Murray Valley Proposed Floodway Network

Proposed floodplain boundary and floodway network around [REDACTED]

Figure 2 –  
Removal of  
Emergency levee  
scenario

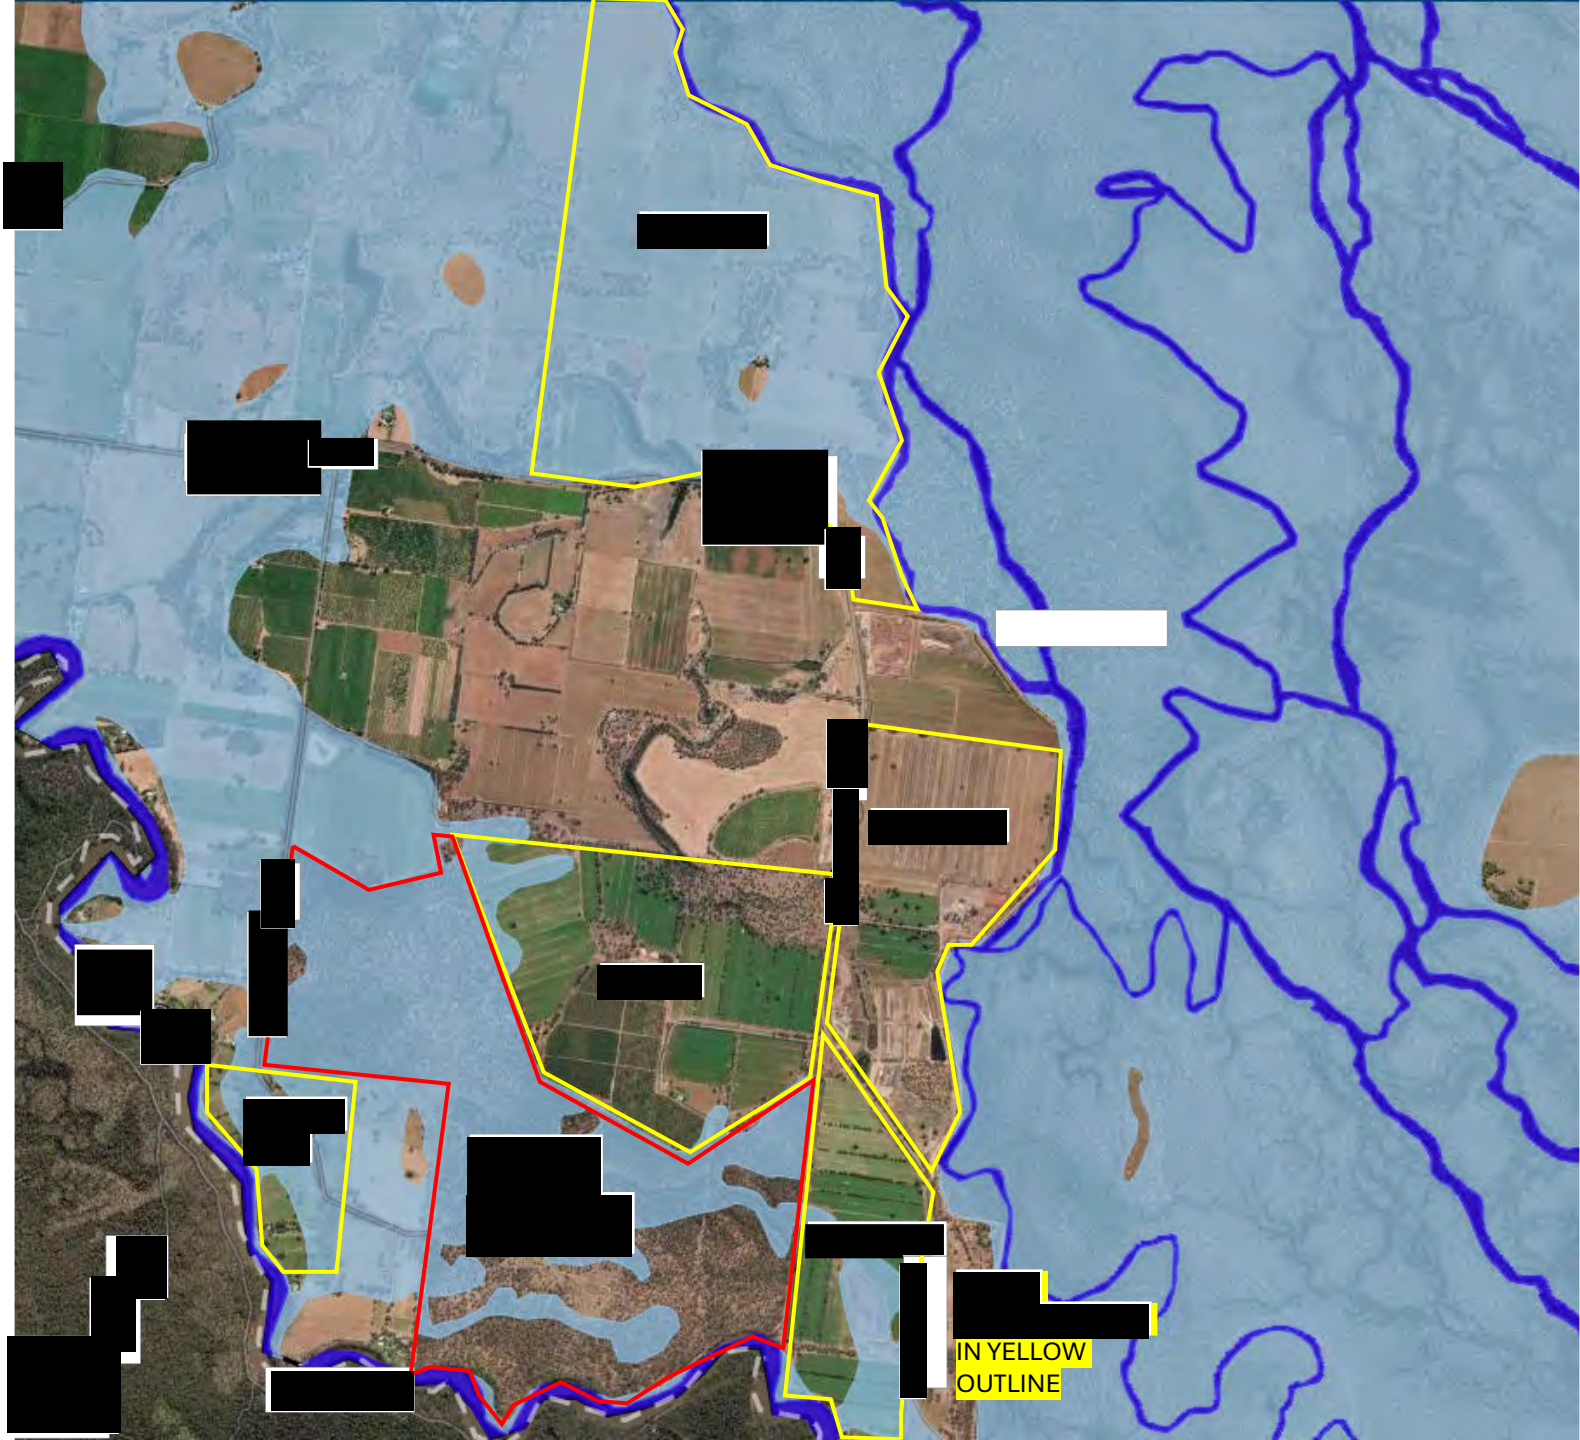
○ Expected levee  
breach points  
during moderate  
to high flood if  
Little Forest  
emergency levee  
removed

Figure 3 – Flood levels and ground levels taken in and around [redacted] during 2022 floods by local Land Suurveyor [redacted] (Note these are reduced levels not AHD)

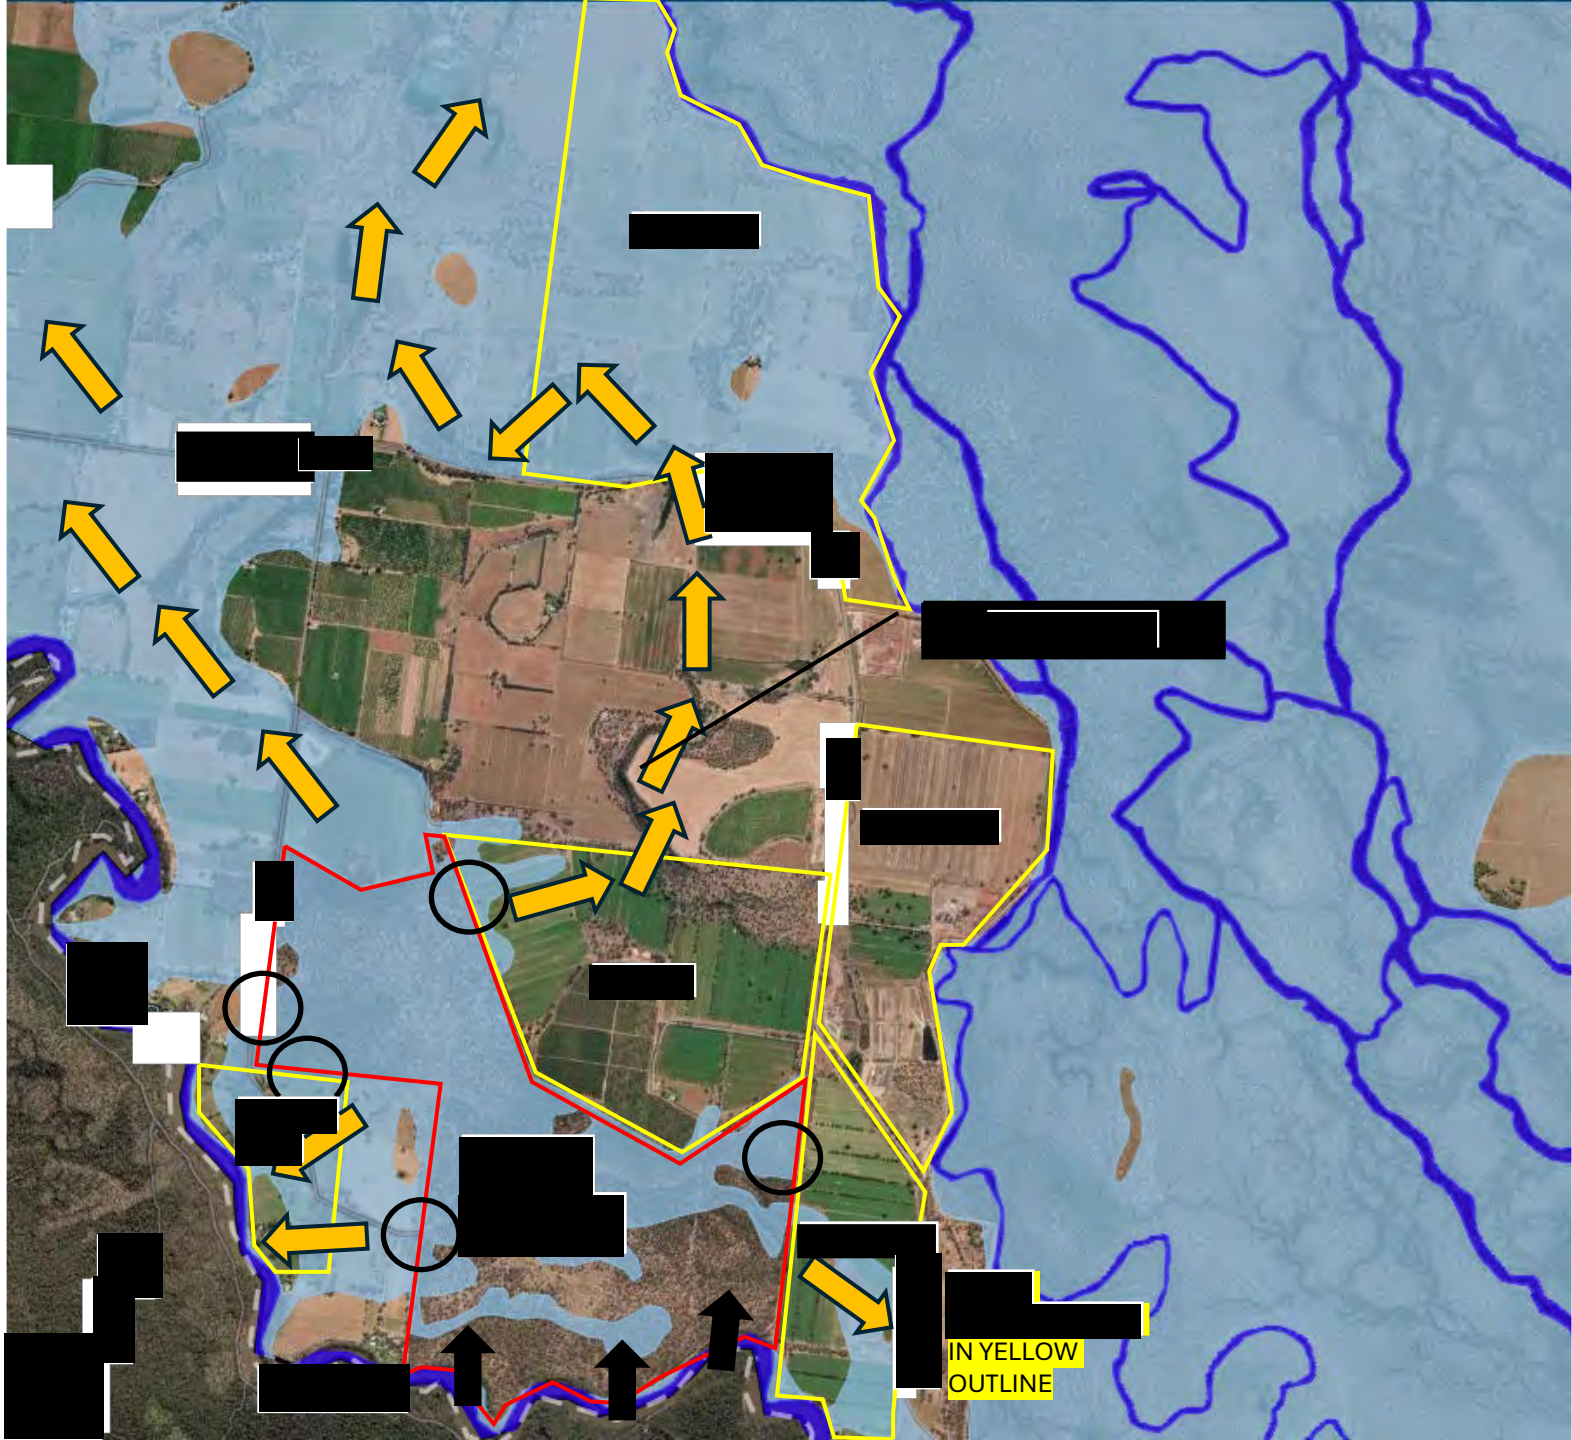
BOUNDARY  
LINE  
IS  
NOT CORRECT

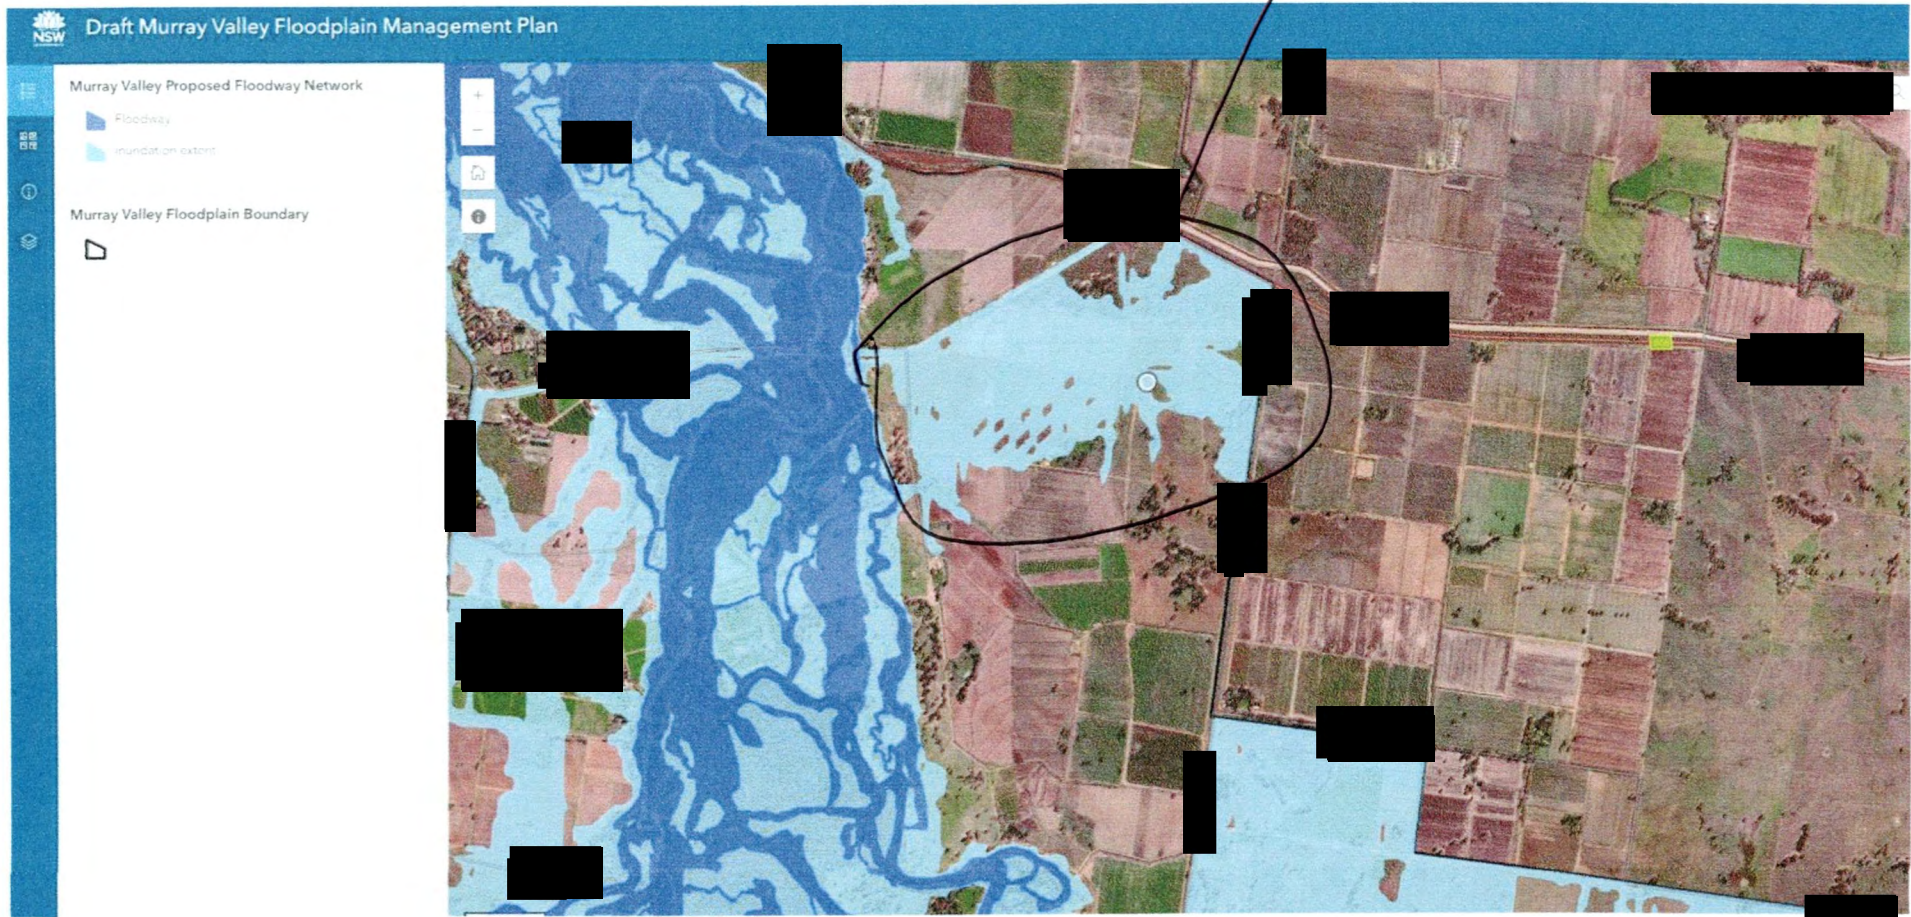
NBUBA FLOODED

NEVER  
~~NEVER~~ FLOODED

Proposed floodplain boundary and floodway network around [REDACTED]

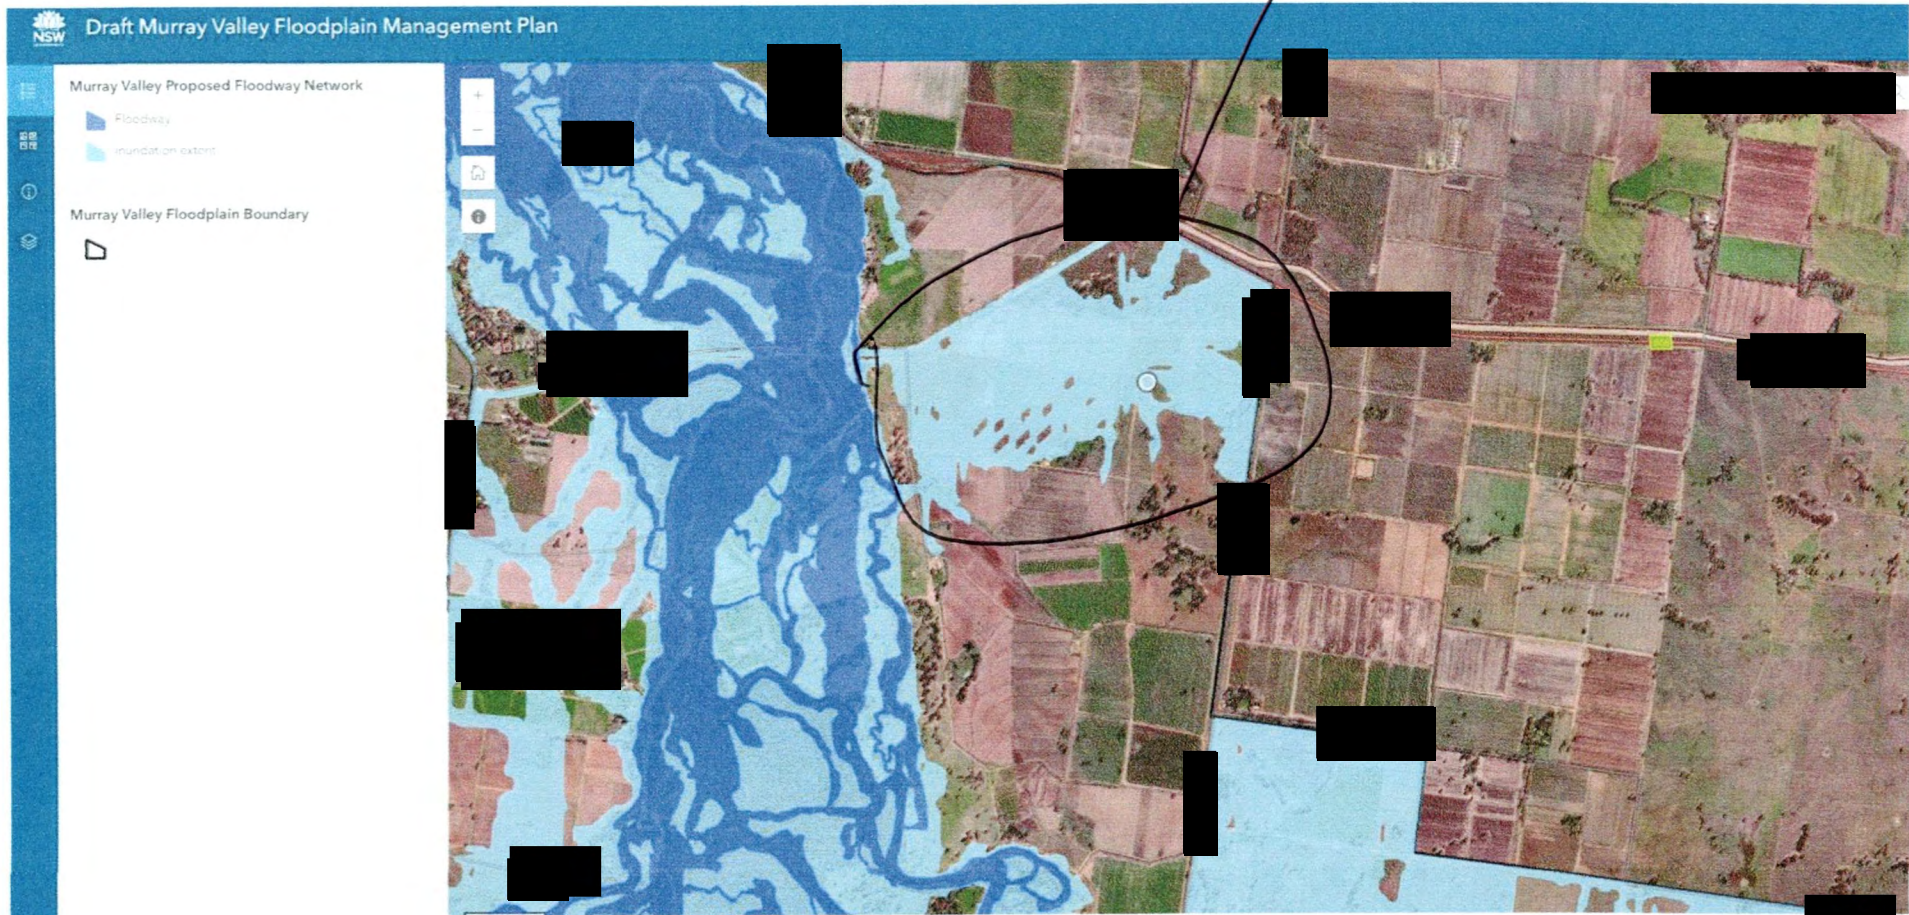
NBUBA FLOODED

NEVER  
~~WATER~~ FLOODED

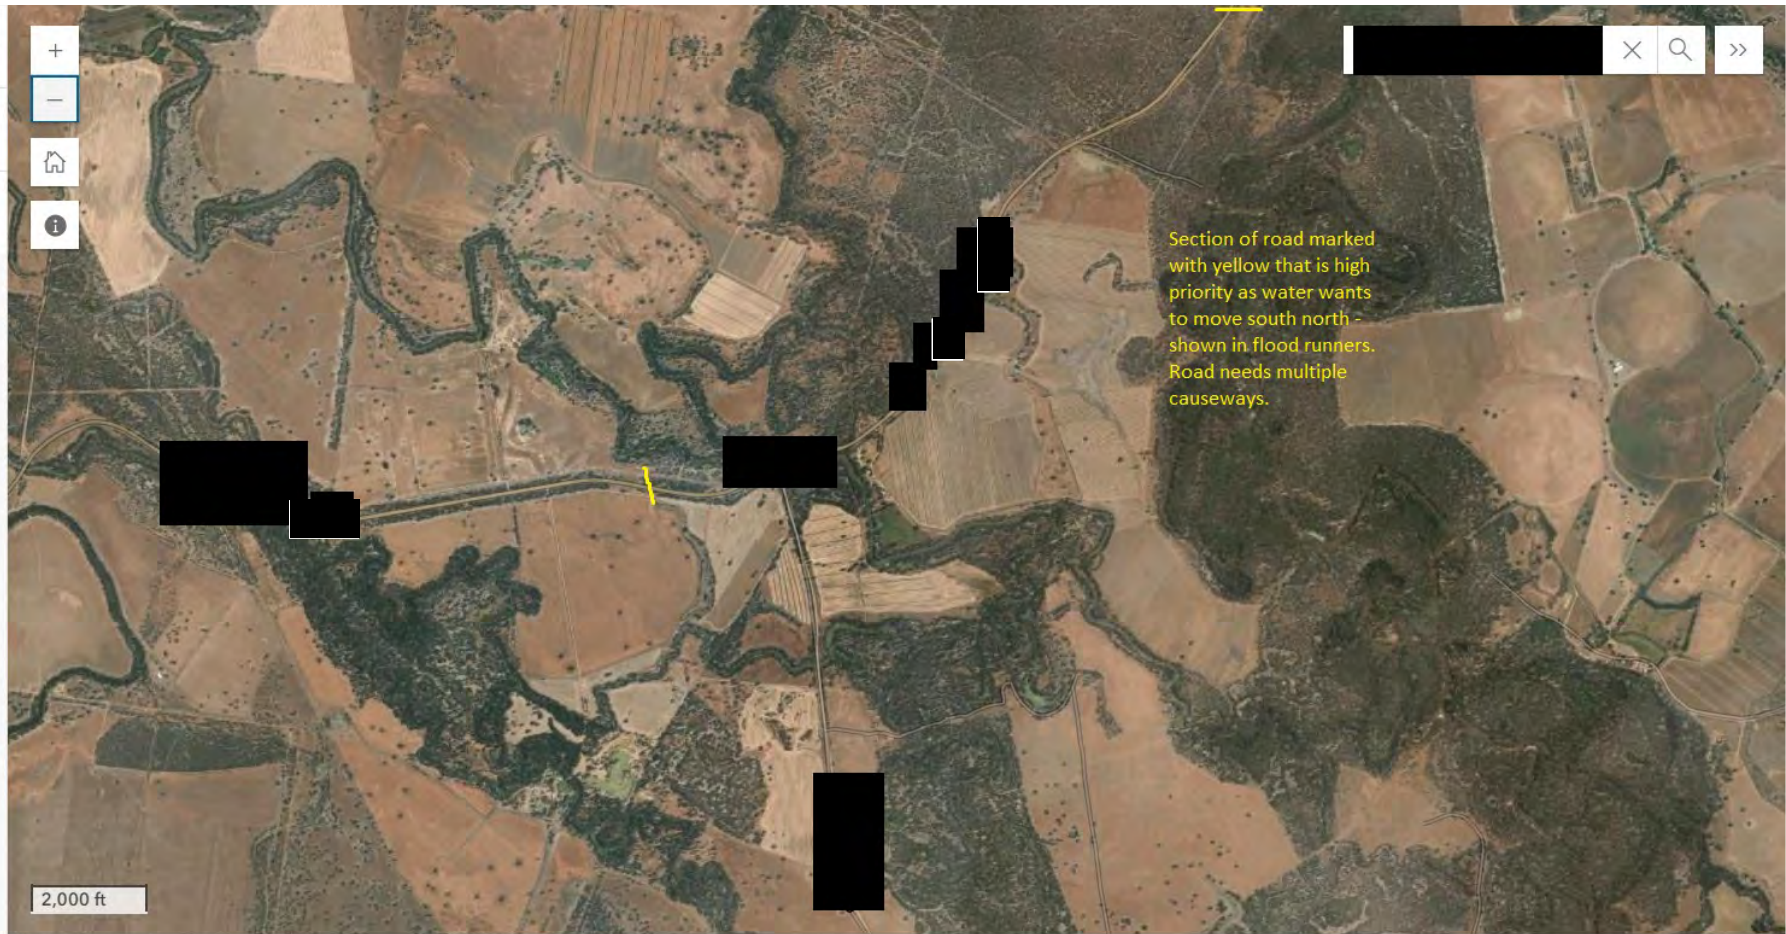
BOUNDARY  
LINE  
IS  
NOT CORRECT
